CERL Technical Report 99/91
November 1999

High Temperature Hot Water Generator Safety Valve Research at Wright-Patterson AFB, OH

Investigation of Chronic Safety Valve Leaks

Figure 1. HTHW safety valves in Bldg 1240.

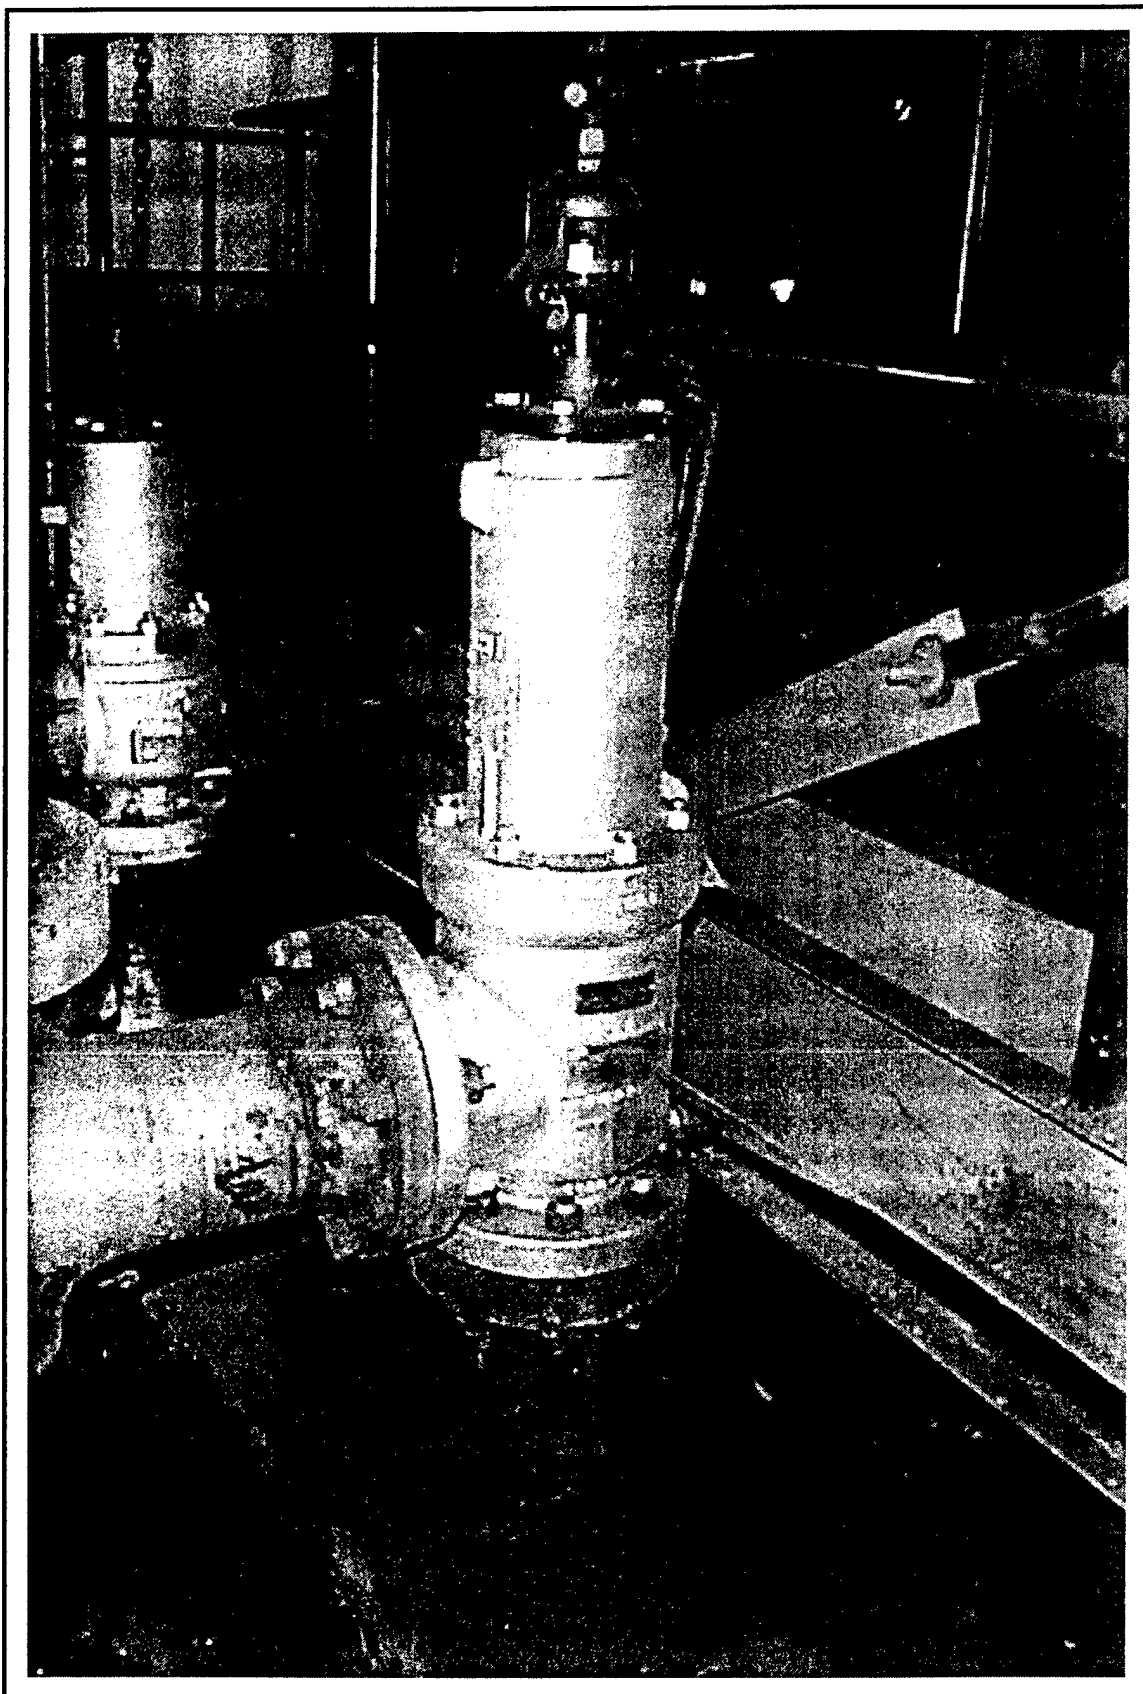
CERL and SAI conducted a site visit to WPAFB Plant 1240 on 22 December 1998. During the site visit, the investigation team examined the installed safety valves (Figure 1), reviewed plant drawings, recorded plant conditions, and interviewed plant staff. The team observed that the installed safety valves were not marked as the type required by the American Society of Mechanical Engineers (ASME) Boiler and Pressure Vessel Code (ASME BPVC) Section I Part PG-110. ASME BPVC requires fired pressure vessels to be protected with "V" stamped safety valves. Additionally, the legibility of the valve data was poor. Table 1 lists the seven items required to appear on the name plate or etched on the valve body.

Two valves are required on each of the four HTHW units, for a total of eight safety valves. Only two of the installed valves had "V" stamps. One additional valve may have had a "V" stamp, but it was hidden from view by the HTHW generator piping. Three valves had "UV" stamps. "UV" valves are not permitted on fired pressure vessels built and operated as ASME BPVC Section I systems. Two valves had neither "V" nor "UV" stamps. Appendix A to this report tabulates the legible data collected as part of this inspection.

Based on the code requirements and the available information, the team recommends that two "V" safety valves be installed on each HTHW unit. These valves should be sized to relieve the full HTHW unit capacity at 6 percent of the maximum allowable working pressure (MAWP) of 500 psig.

Figure 2. Nitrogen (N_2) expansion tanks.

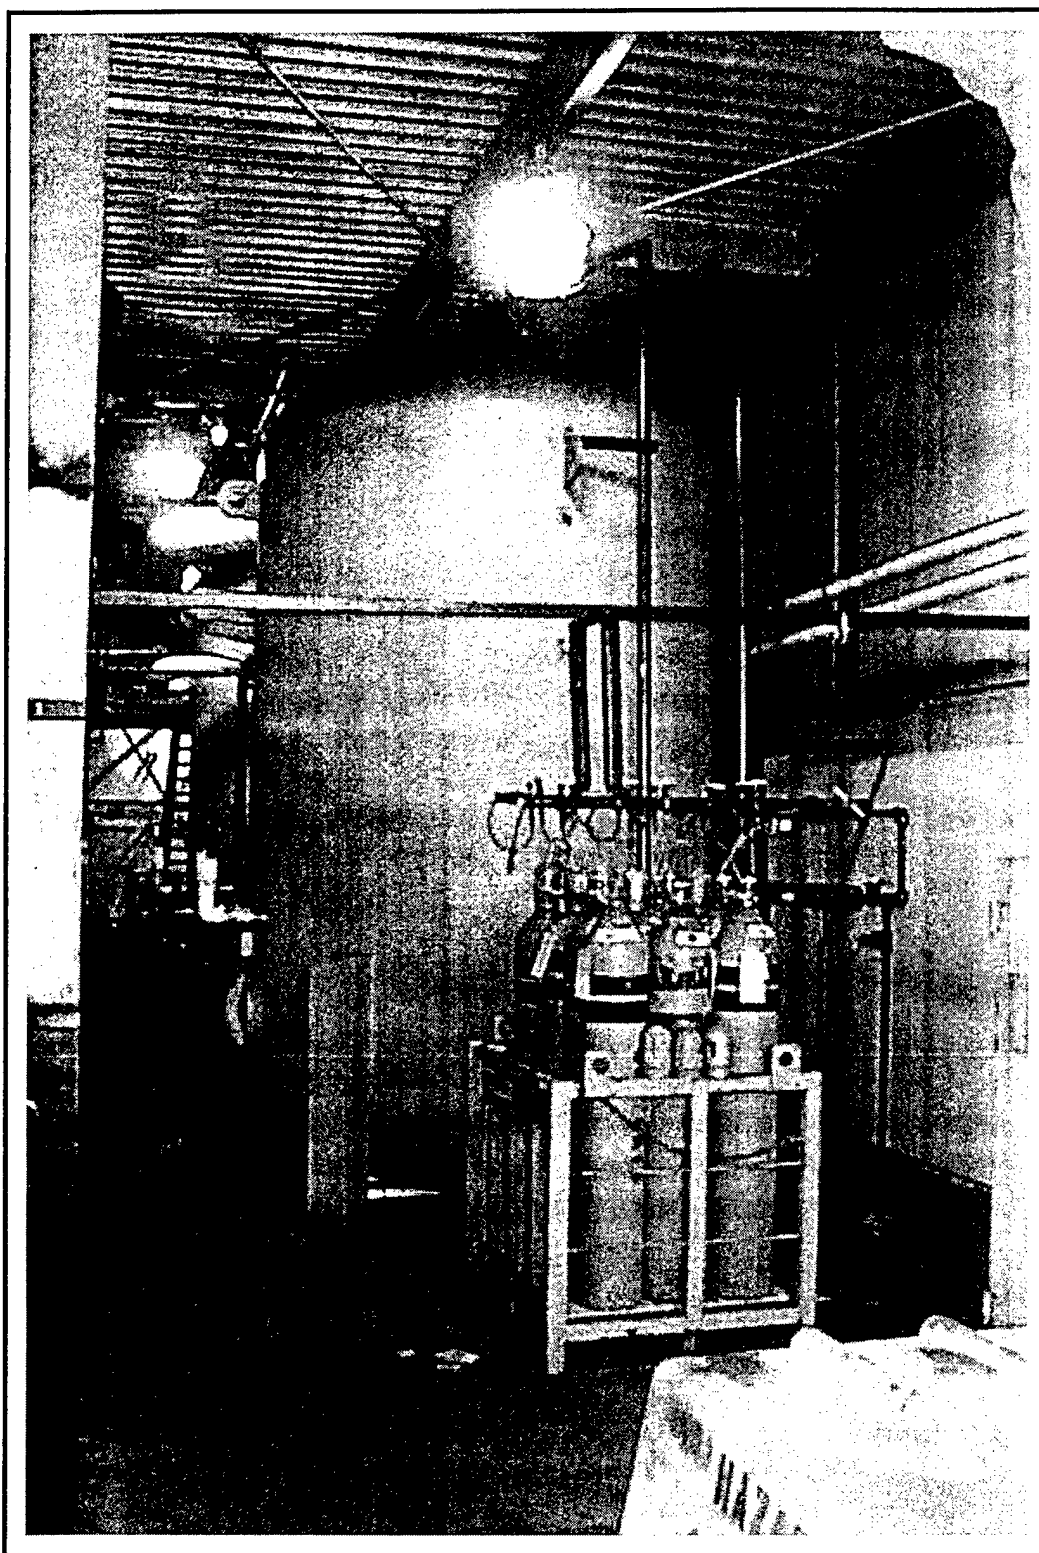
Plant 1240 has a computerized plant data recording system that is useful for investigating plant upsets. Unfortunately, system pressure is not recorded as a trend. It is recommended that the screen interface be modified to trend plant pressure and nitrogen (N₂) expansion tank level (Figure 2) to help operators and maintainers troubleshoot pressure control problems.

Figure 4. HTHW blowoff piping.

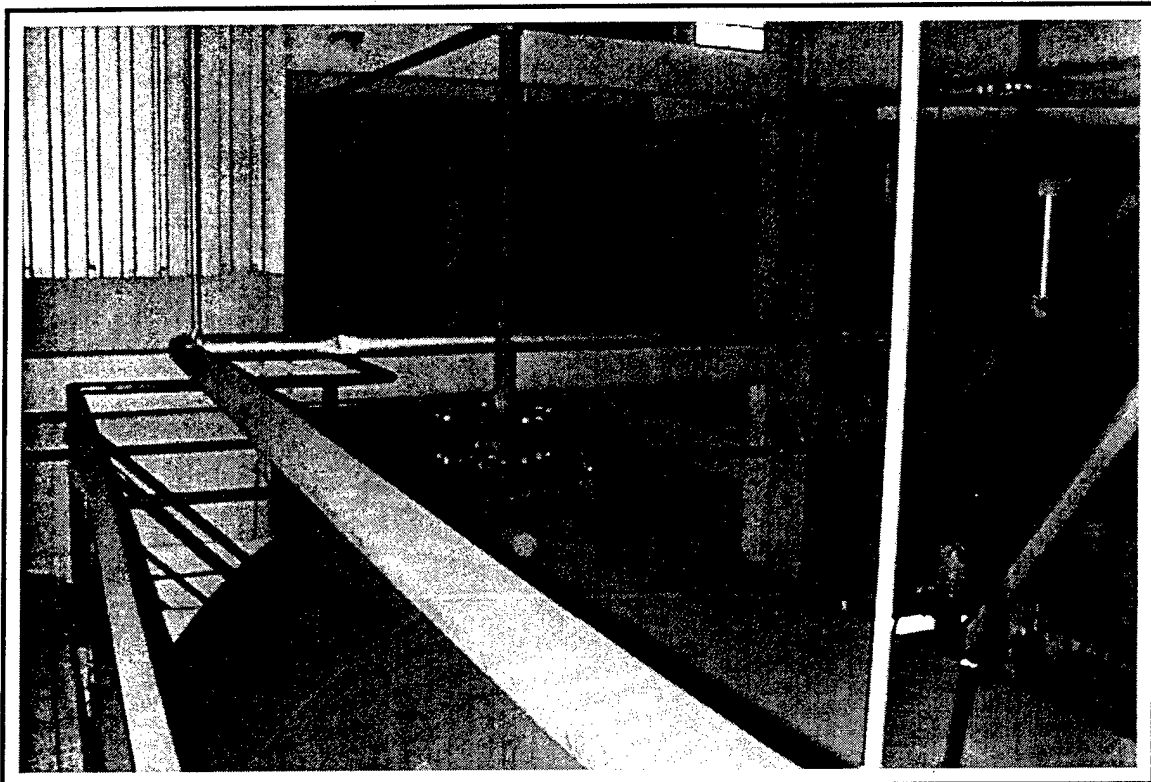
The current discharge piping arrangement (Figure 4) experiences large vibrations when discharging HTHW to the blowoff tank (Figure 5). When a transient necessitates discharge of HTHW, the blowoff valve (Figure 6) opens to release water at 350 °F and 440 psig to near ambient conditions. The pressure at the outlet of the valve will be slightly above ambient conditions due to flow resistance, but the increase in pressure will not be sufficient to prevent some of the HTHW from flashing to vapor. At 350 °F, steam occupies about 180 times more space than liquid water. Although only about 20 percent of the HTHW will flash to steam at atmospheric pressure, the acceleration of the two-phase mixture in the discharge pipe will cause severe water hammer.

The team and plant staff concluded that the valve is not placed in the best position to minimize water hammer when discharging HTHW to the blowoff tanks. The team recommended that the blowoff valve would have the least water hammer when located to discharge into the top of the blowoff tank (Figure 8). This would eliminate two-phase flow in the discharge line from the blowoff valve to the blowoff tank.

Figure 7. Blowoff tank vent on the roof of Bldg 1240.

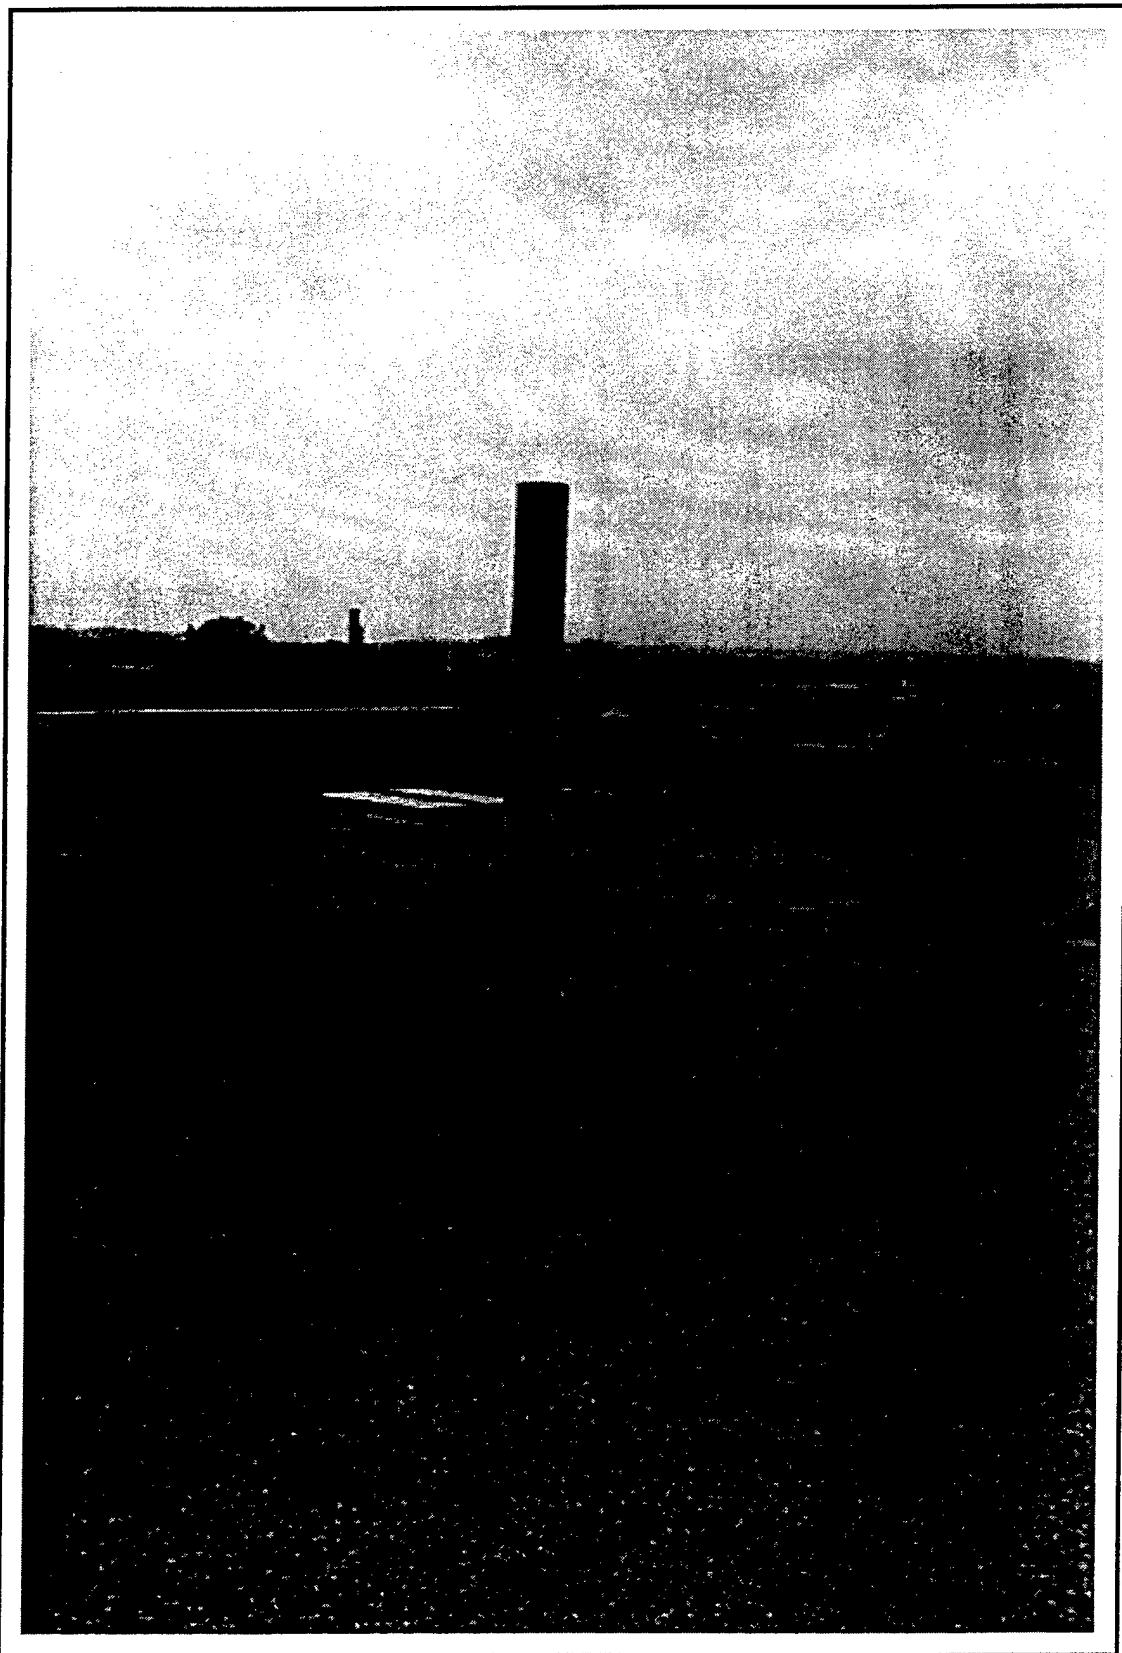
The plant staff was also concerned that the present location and size of the overflow piping of the blowoff tank could cause damage to the plant roof. The steam created when the HTHW flashes into steam is vented out of the blowoff tank to the roof (Figure 7). The roof was inspected; currently there appears to be no damage to the plant roof. However, should there be prolonged venting, vent drains and piping should be installed to minimize exposing the flat roof to hot water and steam. If needed, SAI can provide drawings and specifications of typical vent drains.

Figure 9. Blowoff valve modification.

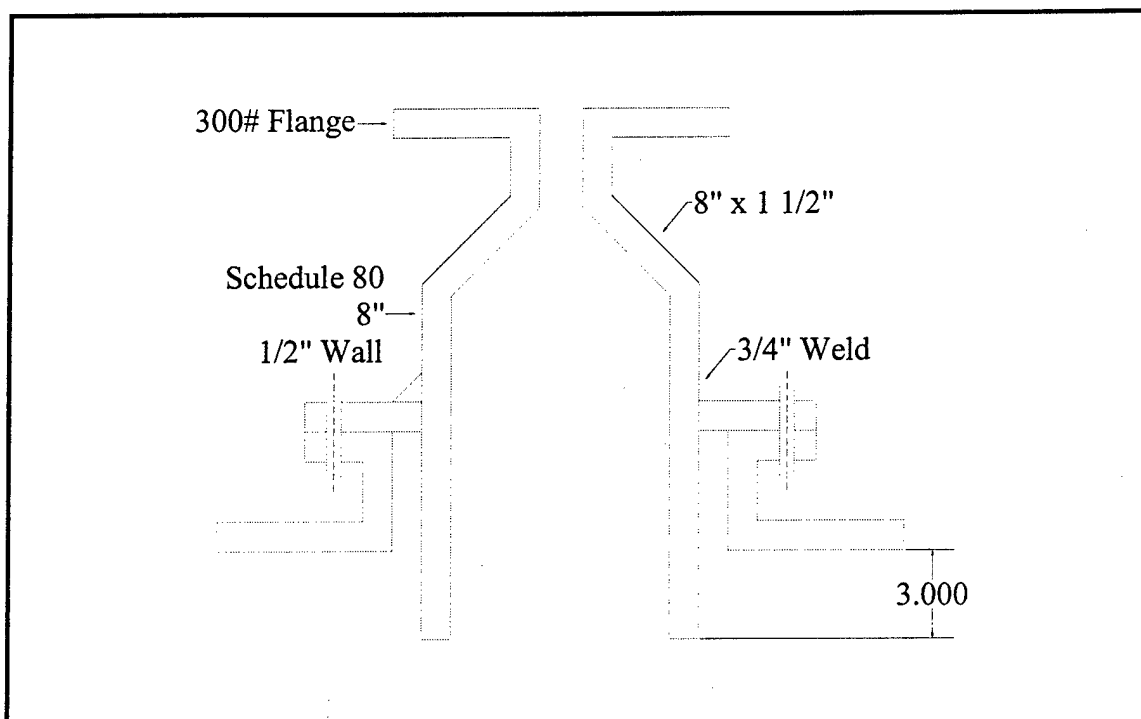
The least costly solution would be to move the HTHW blowoff valve to the top of the blowoff tank. The discharge of the 1.5-in. valve would expand into an 8-in., schedule 80 pipe as it enters the expansion tank. The expansion will drastically reduce the flow velocity in the pipe. HTHW flashing to steam will still make noise, but some noise could be reduced by installing sound attenuating material around the blowoff valve area. Figure 9 shows the recommended configuration.

Figure 10. Current blowoff tank bracing.

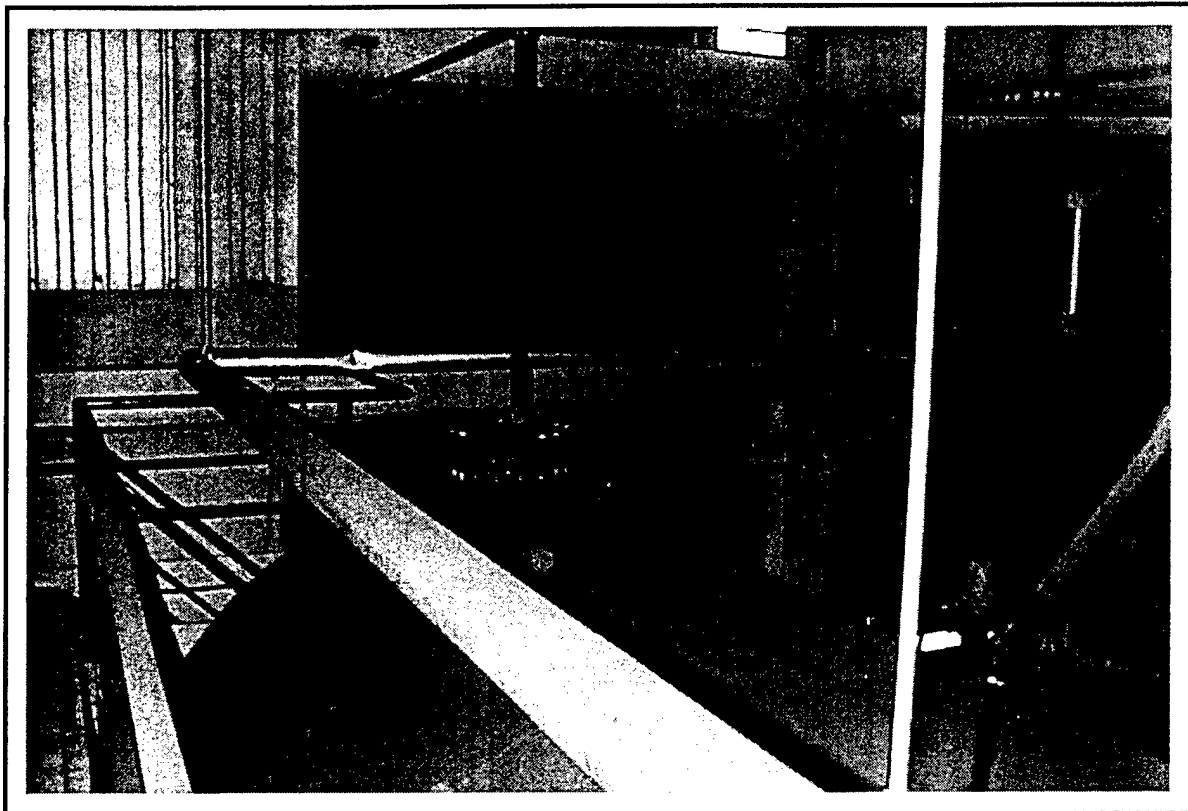
Regardless of what solution WPAFB selects, the system needs to be modified to eliminate HTHW blowoff line water hammer. Additionally, the pipe anchoring needs to be corrected to allow for thermal expansion. The current bracing (Figure 10) seems to over-constrain the piping that was vibrating due to water hammer. The pipe needs to be allowed to expand along its length to prevent bowing in the pipe. This could be done with a three-sided rectangular piece of metal. The three-sided rectangular piece of metal should be as long as the pipe itself. The pipe should be placed between the two opposite sides of the piece of metal. The pipe should then be anchored with some u-bolts that will clamp the pipe to the piece of metal.
